TECHNICAL SERVICE BULLETIN

Technical Service Bulletin Number- TSB0003

Item, Unit or Assembly Affected - All Ford Transit Vans without 67C-Upfitter switches AND equipped with Wheelchair Lift (Braun, Ricon, etc.) or other accessory requiring more than 60 Amps and wired to the Customer Connection Point (CCP) located on the street side of the driver seat pedestal near the "B" Pillar

Reason for Bulletin - Ford Transit vans NOT equipped with the optional 67-C Upfitter switches package are limited to one, 60 Amp capacity connection point at the pedestal of the driver seat. Wheelchair lifts (or other accessories) that draw in excess of 60 Amps and are supplied with a Circuit Breaker that is greater than 60 Amps may blow the Ford Factory 60 Amp Fuse before the Circuit Breaker trips when using the Lift (or other accessory).

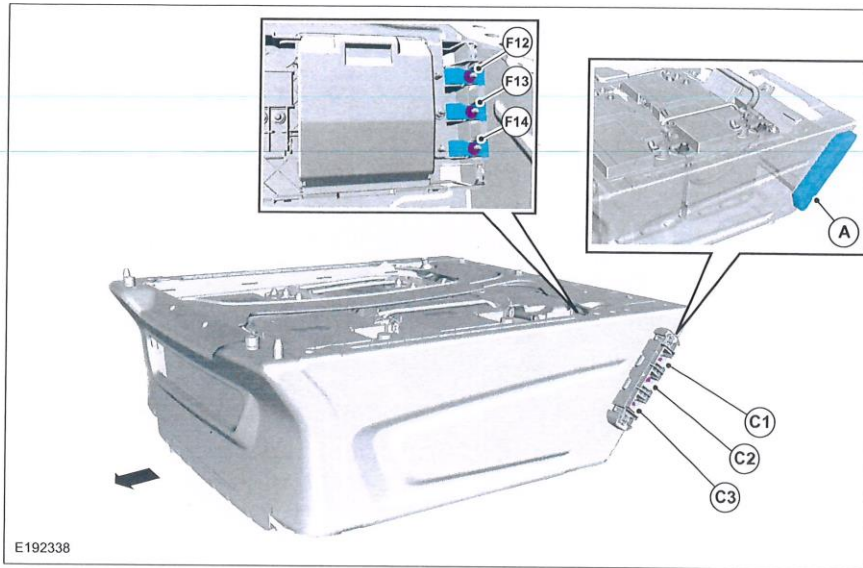
Action Required - Determine if the vehicle is equipped with the 67-C package or has been upgraded by observing the CCP (Customer Connection Point) located on Driver Seat Pedestal near the "B" Pillar. If only 1 connection point is available, the capacity is limited to 60 Amps. In order to increase capacity, a CCP kit (Ford Part Number BK2Z-14S411-A) must be ordered and installed. This will provide up to 3, 60 Amp connection terminals (for a total of 180 Amps). Please note that most Lifts do not require more than 120 Amps. The Ford kit provides 2 additional connections, so 1 kit can upgrade 2 vehicles. The Circuit Breaker provided with the Lift (or other accessory) must still be used to protect the circuit. If the vehicle is already equipped with the upgraded CCP and fuses or circuit breakers are tripping, there may be other issues with the lift or wiring unrelated to this Bulletin that must be investigated and corrected.

Fig. 1: Location of empty B+ battery post

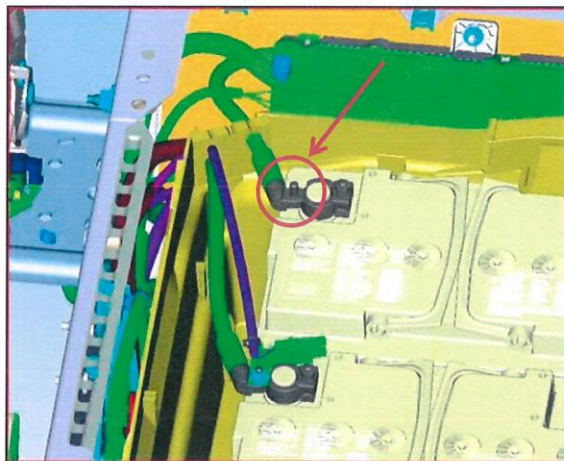
Vehicles equipped with dual AGM batteries will have a single empty B+ battery post on the rear or second AGM battery (see figure 1). Upfitters wishing to connect to this terminal must adhere to the following guidelines:

- Use only a W520101-S437 nut to secure the aftermarket eyelet (M6 - Electrolytic zinc plate, trivalent chromate, and clear sealer, with integral torque control lubricant). **No other nut or finish may be used.**
- The additional cable eyelet must have a complete flush contact to the terminal and be fully secured.
- The nut must be torqued to **8Nm [+/- 1.2Nm]**.
- The additional battery connection must be protected with an appropriately sized fuse.

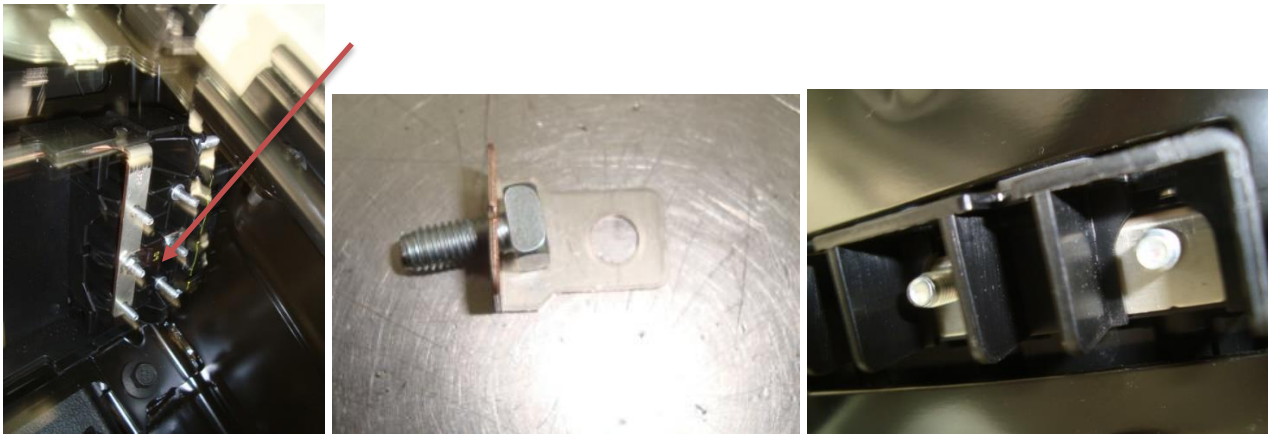
8. Note existing center terminal and blade fuse. This provides 60 Amps of power. Each additional terminal (up to 3 total) will provide an additional 60 Amps. Since most Wheelchair Lifts will only require 70-90 Amps total (and should be protected by separate circuit breaker accordingly), only 1 more terminal will need to be added. New terminal may be added at either side of existing center terminal. If power above 120 Amps is required, both additional connections will need to be installed.

9. Install addition Lug in the same manner as the existing (note the direction of the stud (bolt) through the spade connector). Add connector and blade fuse.
10. Reinstall all items in reverse order.
